Re: Response to Correspondence 30707 for FCC ID: AZ489FT5846 with Confirmation Number: EA585607.

Motorola Inc., 8000 West Sunrise Boulevard, Fort Lauderdale, Florida 33322, herein submits its response to the 17th April 2006 Request for Information on FCC ID: AZ489FT5846, EA585607 via Correspondence Number 30707.

Ambient Noise Response

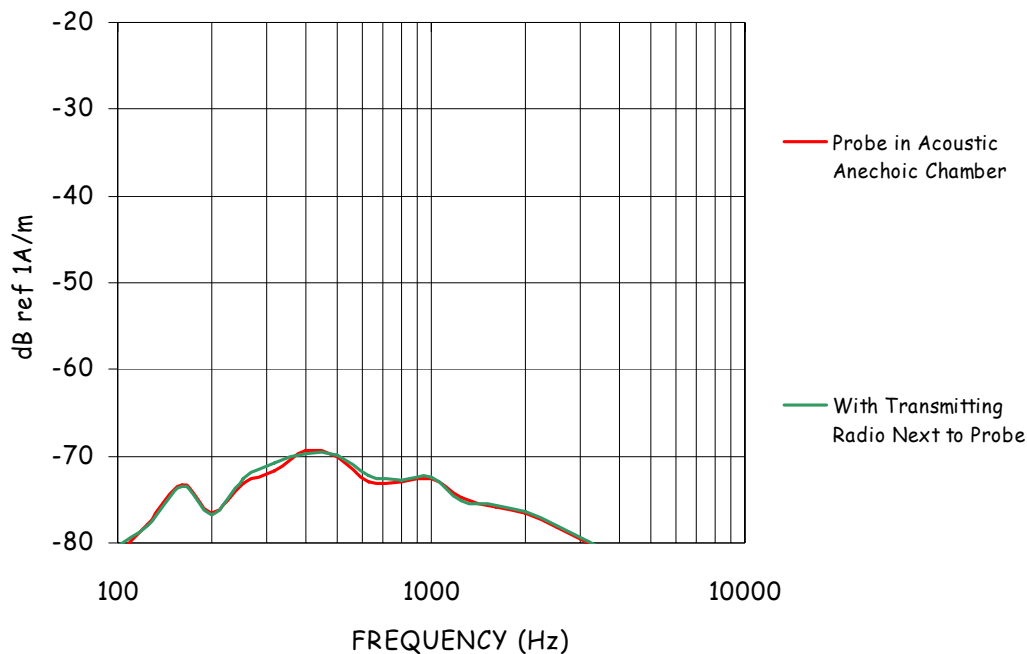
Q11. Please demonstrate that RF emissions from the phone do not effect the T-coil measurements.

The graph below shows two ambient noise level responses. The baseline is the probe in the anechoic chamber by itself, and then a phone in a call placed next to the probe. The results show that there is negligible interference reflected in the measurement system with respect to the presence of the RF emissions, and as such the T-coil data were unaffected.
